MFN 16-076

**Subject: Response to Request for Additional Information for the Review of the GE Hitachi Nuclear Energy, Morris Operation, Topical Report NEDE-31559, "GE Hitachi Nuclear Energy Quality Assurance Plan Morris Operation," (CAC No. L25119)**

Response to NRC Request for Additional Information (RAI)

**FIGURE 1: MORRIS OPERATION ORGANIZATION**  
(Operations below dotted line are represented at GEH Morris)

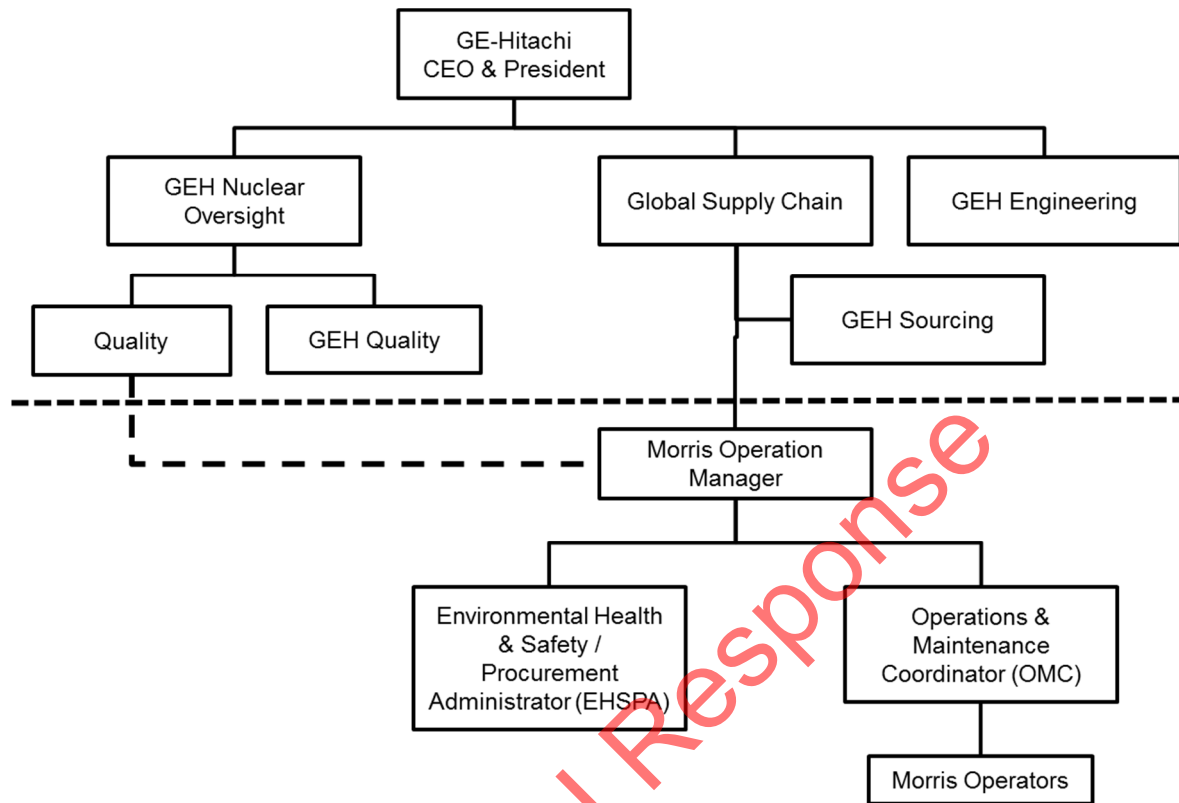
Section	Summary of Change
Policy Statement	Changed the name to the current Vice President, Emily Martin (Not Related to RAI)
Section 1	
1.4.4	Added text to clarify Quality activities and responsibilities. (Not Related to RAI)
1.4.5	Changed QA to Quality consistent with the current organization (Not Related to RAI) Deleted Item (i) regarding 10 CFR Part 71 activities
Figure 1	Modified to reflect the proper location of the Quality organization (Not Related to RAI)
